KITTITAS RECLAMATION DISTRICT
 ELLENSBURG, WASHINGTON
 South Branch Canal
 Canal Lining Improvements

Plan & Profile
 Sta. 404+75 to 410+25

CG106
 SHEET 20 OF 85

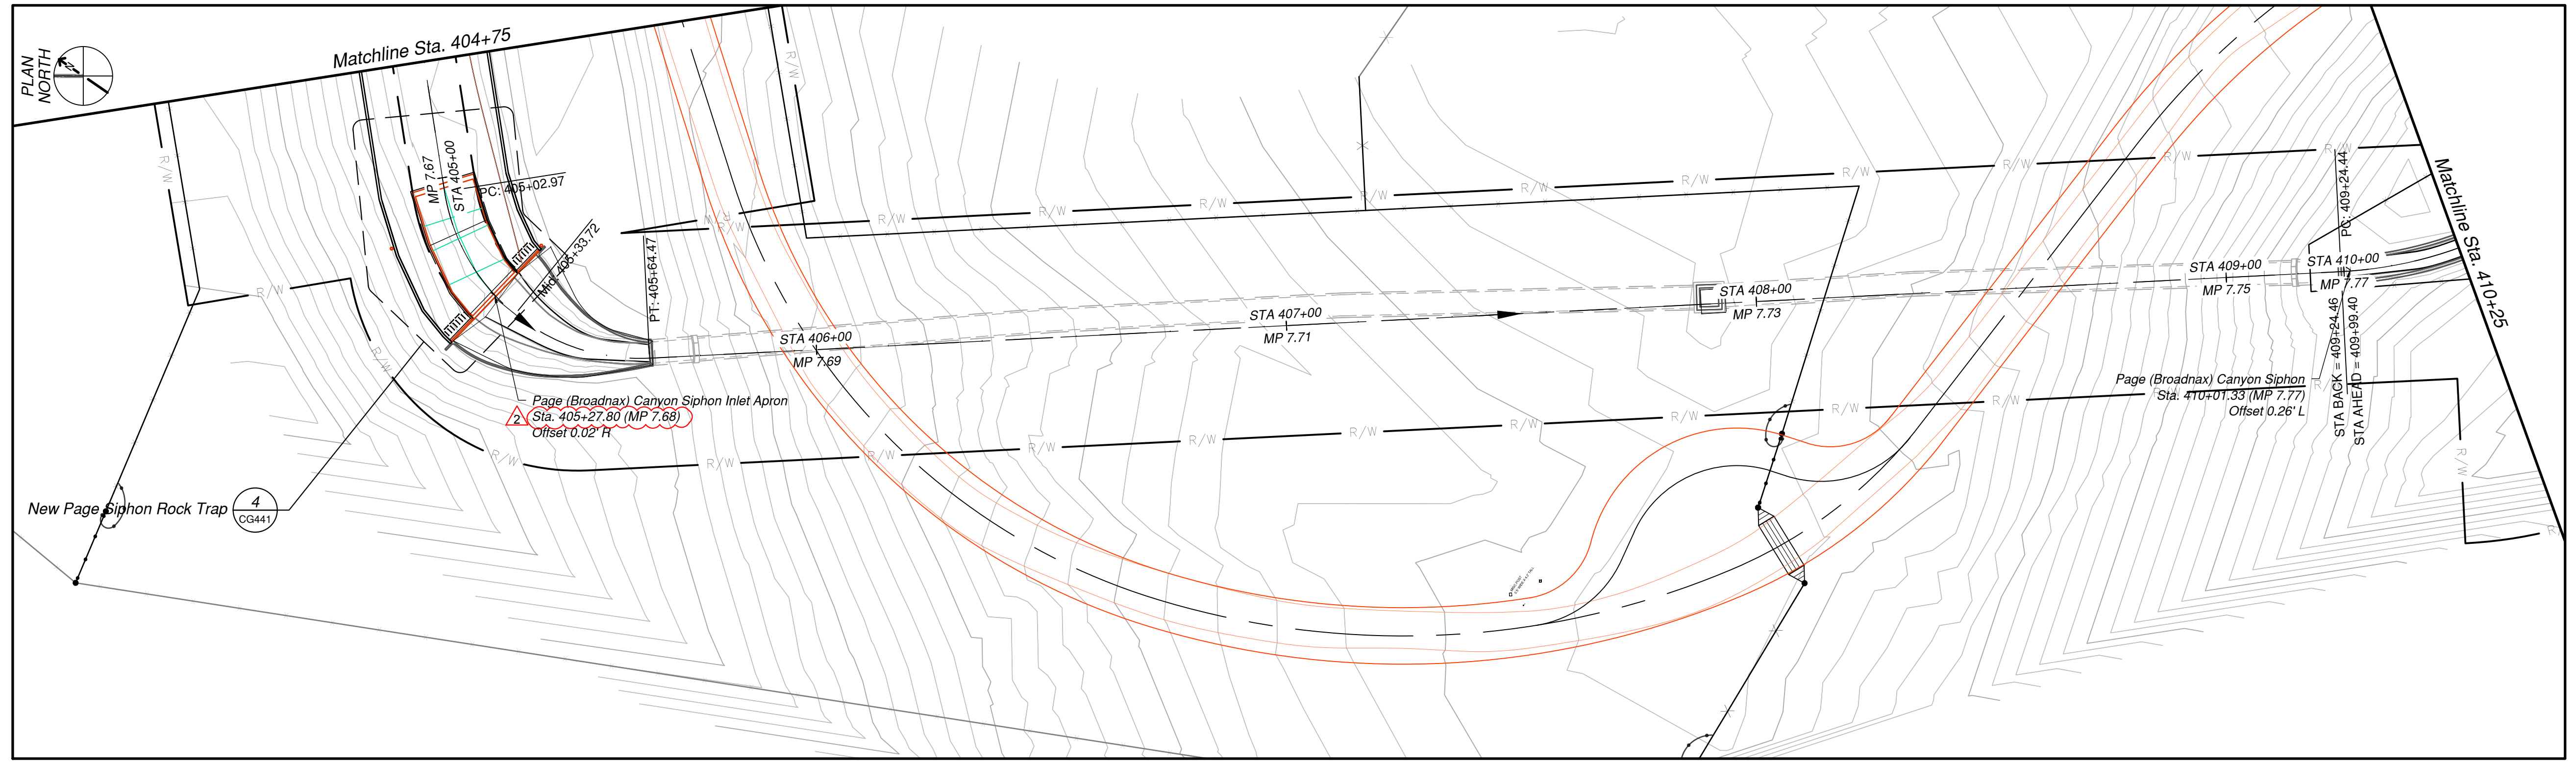
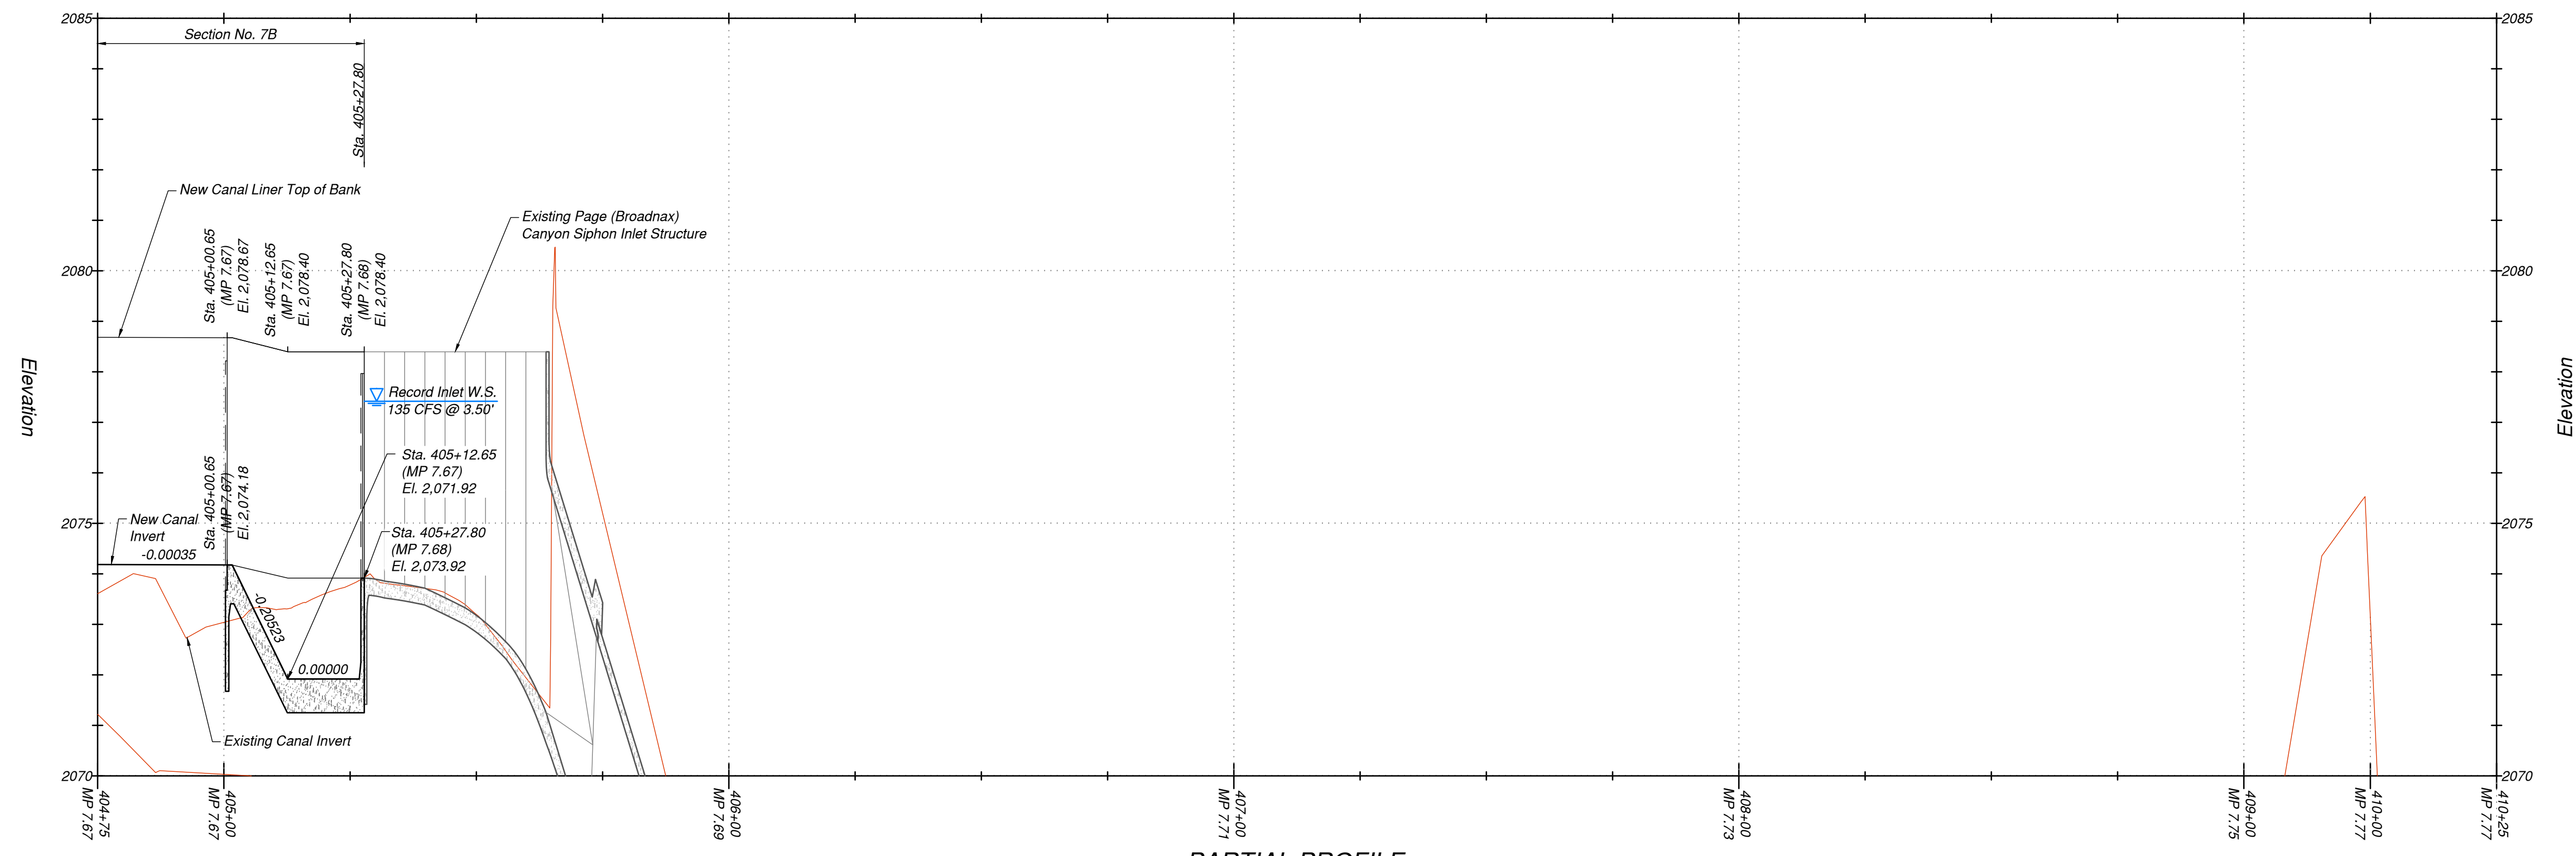
REV. NO.	REV. DATE	REV. BY	DESCRIPTION
2	09/06/2019	DAVID L. ALLISON	CORRECTED PLAN CALLOUT OF SIPHON INLET STATION FROM 405+28.12 TO 405+27.80 (MP 7.68)
1	04/09/19	REILLY A. HOLLAND	PROFILE STATION AND ELEVATIONS FOR REFERENCE TO PROPER SEGMENT OF PROFILE
